2010SYE011 – 12 Ozone Street, Cronulla

DA10/0076

ASSESSMENT REPORT APPENDICES

1. Construction & Site Management Plan

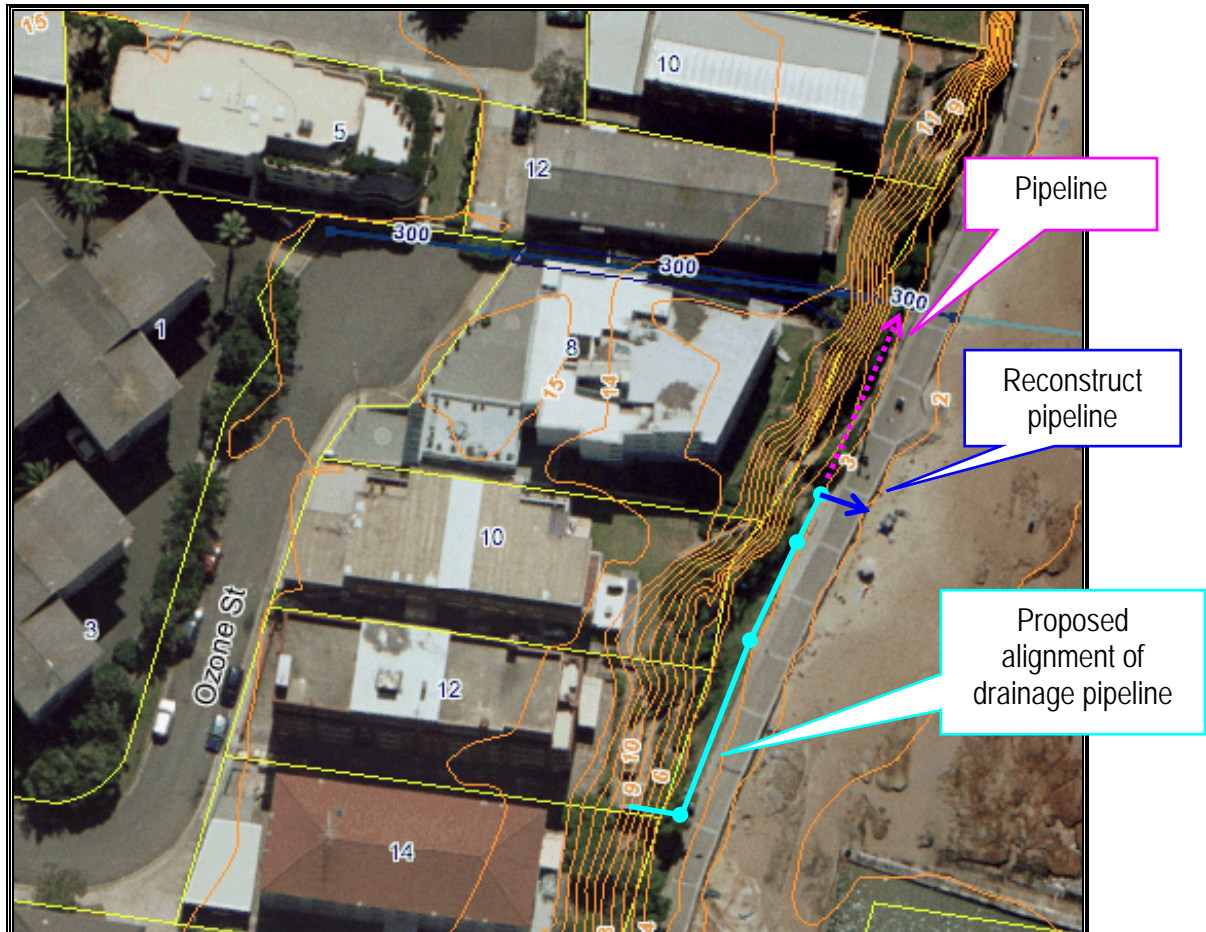
The applicant has submitted an acceptable concept C&SMP drawing. The street adjacent to the property offers an area for the creation of a "construction zone" and the available yard area is large enough to accommodate building materials and equipment. There maybe a need to restrict general on-street parking on the opposite side of the street. Tradesmen will need to compete for nearby street parking for their vehicles. If you choose not to seek a comment from Vanessa Phillips and/or Roger Barnes, I have included custom "conditions" to ensure some degree of appropriate control can be enforced by the P.C.A. and/or Council's Civil Assets Manager.

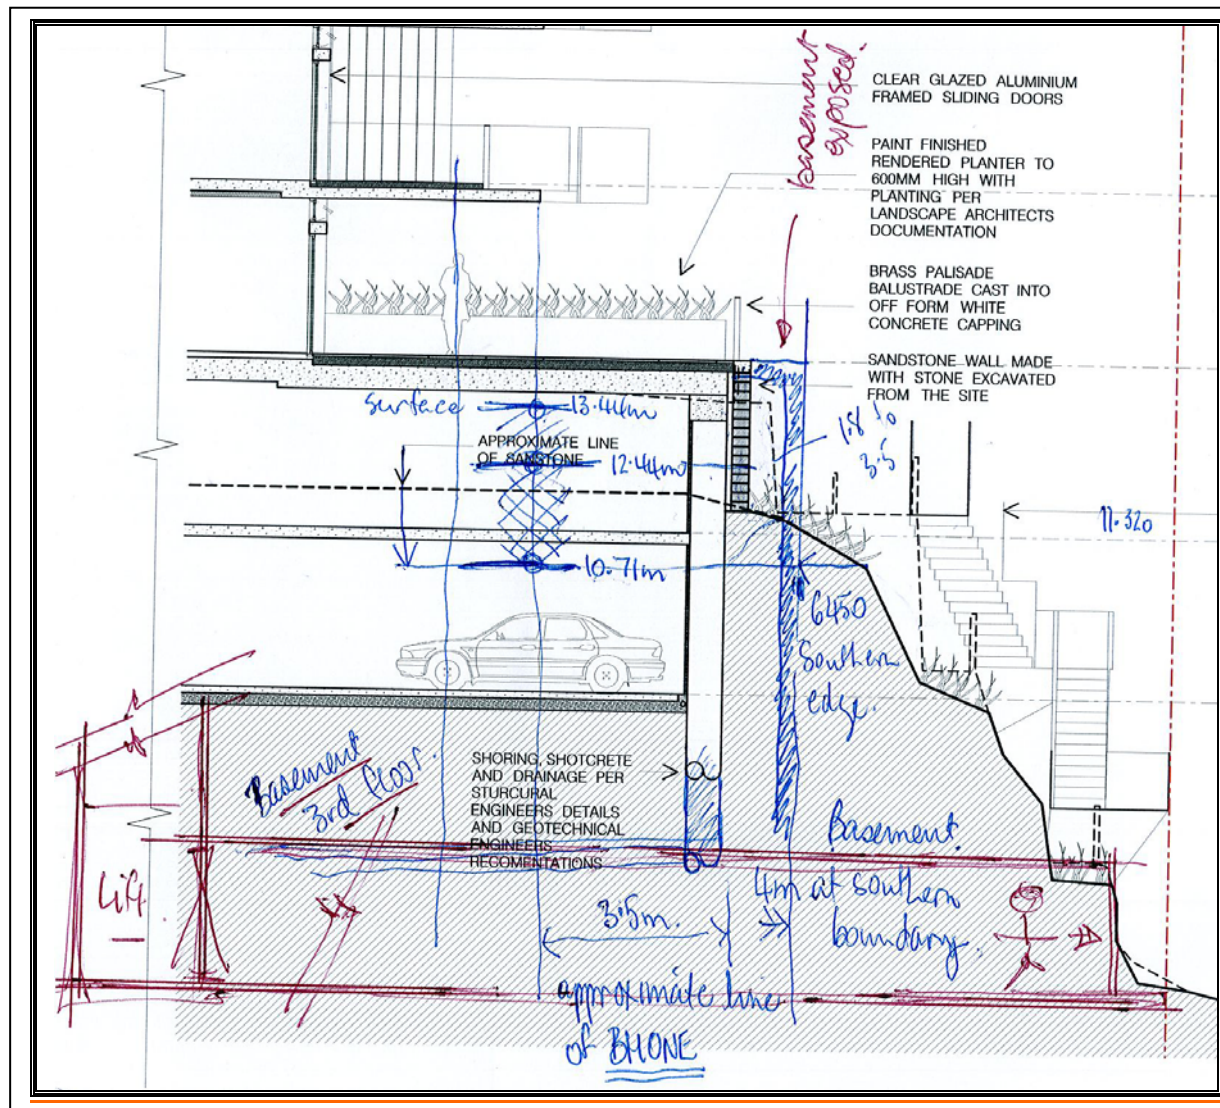
- iii) I have no issues with the thoroughness of the Geotechnical Report or the recommended excavation procedures. The Report is reactive insofar as if something is discovered, here is the remedy.

- iv) I am not convinced that a significant section of the basement wall will not be exposed, above the cliff face, nor if the upper soil stratum will stay in place. To reduce the risk of destabilizing the top of the foreshore cliff face a greater volume of soil should be retained. This could be achieved by redesigning the basement car park; steepening the driveway, adding another basement floor and moving the eastern wall approximately 4m to the west. The resultant redesign will pull the eastern elevation of the basement car park back to complying with the "SETBACK (AS PER SSDCP 2006 – DRAFT AMENDMENT 6 – MAP 23" (blue dotted line detailed in drawing No.5491 sheet DA-1005/B prepared by Candalepas Associates).
